Carmel Valley Association
P.O. Box 157, Carmel Valley, California 93924
www.carmelvalleyassociation.org

March 1, 2008

Comments on Rancho Canada Village Specific Plan DEIR

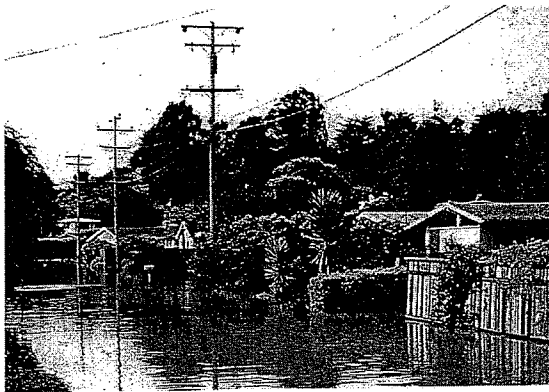
The DEIR fails to address on-the-ground conditions at Carmel Middle School.

Please investigate and explain in detail the impacts of placing 34 flats/condominiums of 2 and 3 stories next to the Hilton Bialek Biological Sciences Habitat at the Carmel Middle

School, and explain how each of those impacts will be mitigated. According to Craig Hohenberger, Habitat Director, this project placement will destroy a wildlife corridor, wipe out natural wetlands, and remove a 100-plus year old California Sycamore. (Figure 20-1).

F. HYDROLOGY

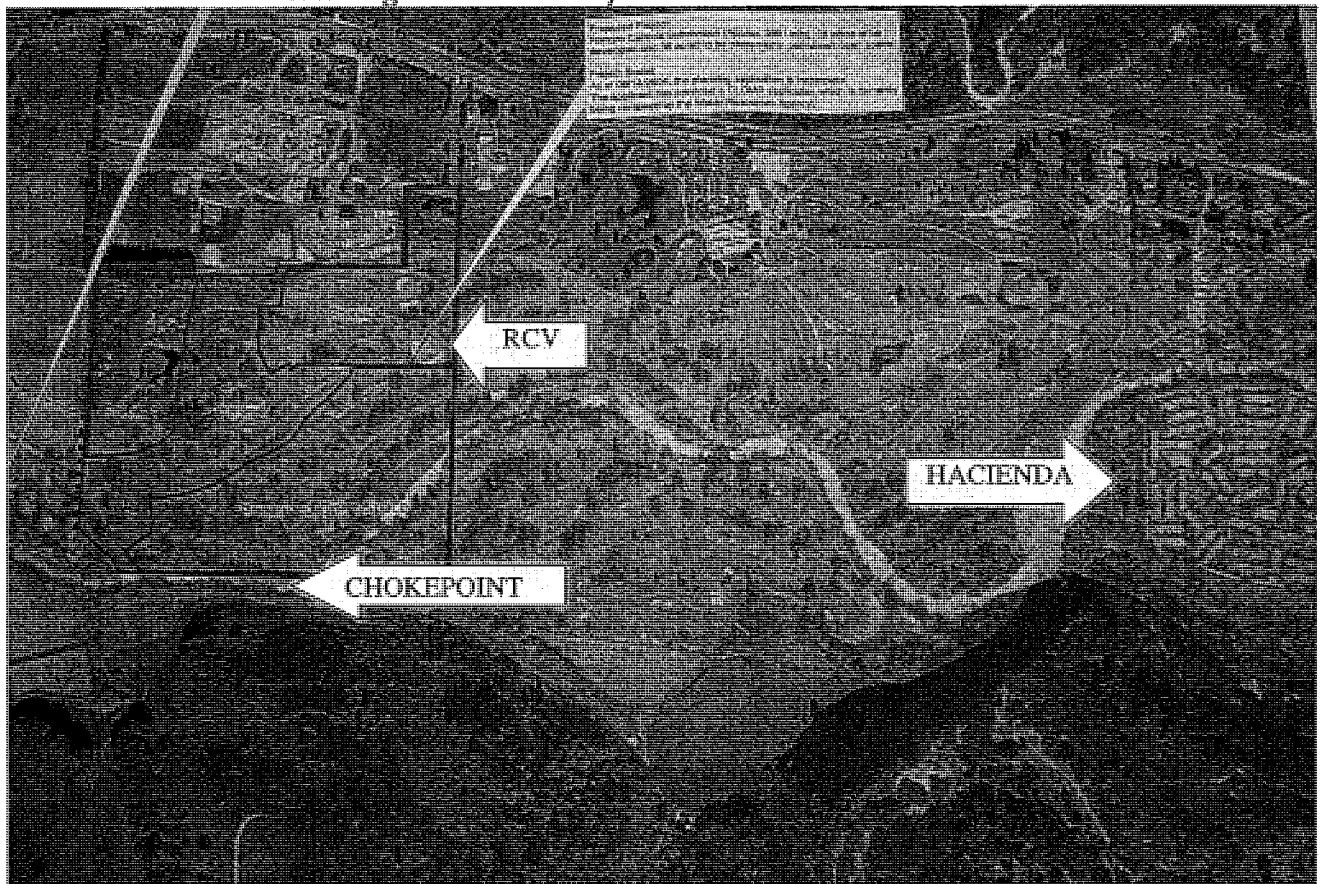
The DEIR significantly fails to address major flooding problems associated with the project, both in terms of upstream flooding as a result of the virtual earthen dam that is to be created as part of this project, and as a result of the impact of the newly displaced 100,000-200,000 cubic yards of water in a major flood event. The major fatal hydrology flaw in the DEIR is that it fails to analyze in a serious way – or at all – the potential flood impacts from the project on properties upstream and downstream from RCV.

At least two critical sets of impacts arise from the RCV fill plans on hydrology:

- The 100,000 to 200,000 cubic yards of new fill in the flood plain of the Carmel River would displace 100,000 to 200,000 cubic yards of water in a major flood event. Where, exactly, will this water go during a major flood event? The DEIR fails to model or adequately discuss such an event. Please provide a map to support your response, because showing the impact on a map is much easier to understand than a prose description. Please specifically identify impacted properties.

Creating a Flood Chokepoint on Carmel River

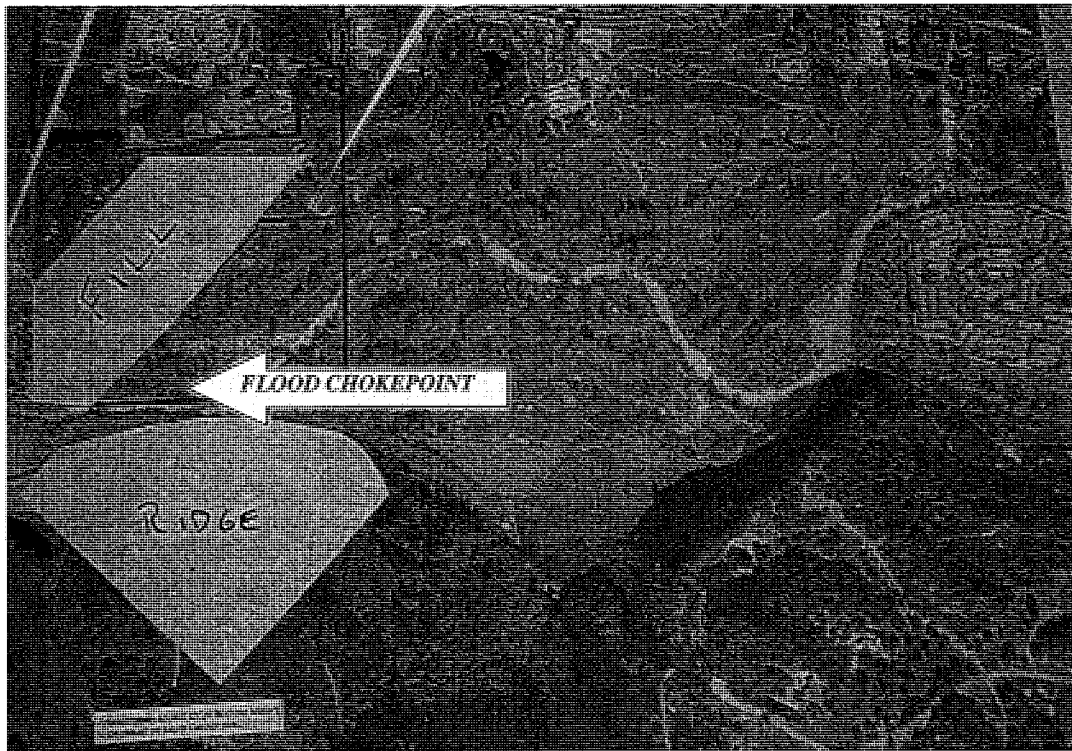
- The so-called “blister” lies downstream on this proposed narrowing of the river, so its removal will have little or no impact on floodwaters backing up behind the chokepoint.
- In its responses to questions and comments, has the DEIR modeled the impacts of the chokepoint? Where is the evidence of that model, and has the model been peer reviewed? We had it peer reviewed by a leading national expert on river flooding (attached) and he found significant omissions and errors in the DEIR. If the DEIR has not analyzed the impacts with an accurate and appropriate model, the DEIR information is not reliable.

Detail of Monterey County Water Resources Agency 2005 Map of Carmel River 100-year floodplain (shown in light blue, with Carmel River visible). RCV project shown in red on left, Hacienda Carmel retirement community on right. Yellow arrows added. The funneling of floodwaters between RCV's 200,000 cubic yards of fill on the north bank and the ridge on the south bank of the river will create a chokepoint that backs up floodwaters directly onto Hacienda, creating higher likelihood of death, injury and property damage at Hacienda.

Same RWA map as above with fill area and ridge highlighted to more clearly show the funnel effect and chokepoint that will worsen flooding upstream from the project toward Hacienda.

Carmel River flooding, with Carmel Lagoon and Carmel Bay in background.

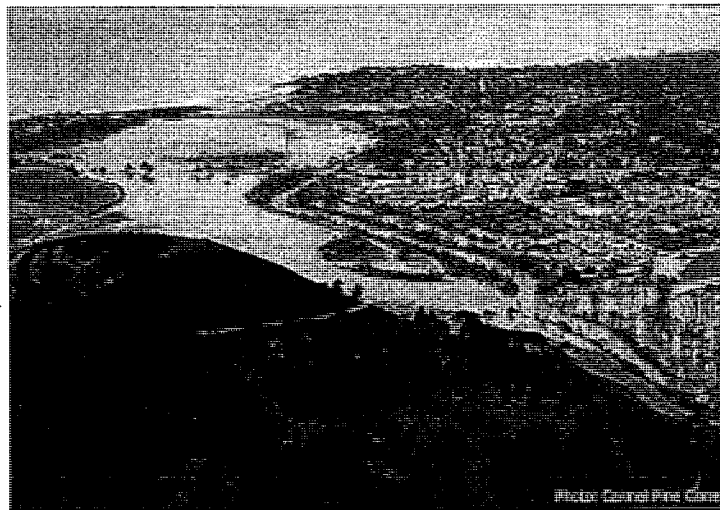
- It is expected that climate change will make river flooding in California streams more severe.² An increase in severity of flooding would make the current 100-year flood level of the Carmel River insufficient for planning purposes. Please provide a full response, analyzing all climate change factors.
 - Did the DEIR model the impacts of climate change for Carmel River flooding? If so, please provide your data and explain how the climate change information changes the assessment.
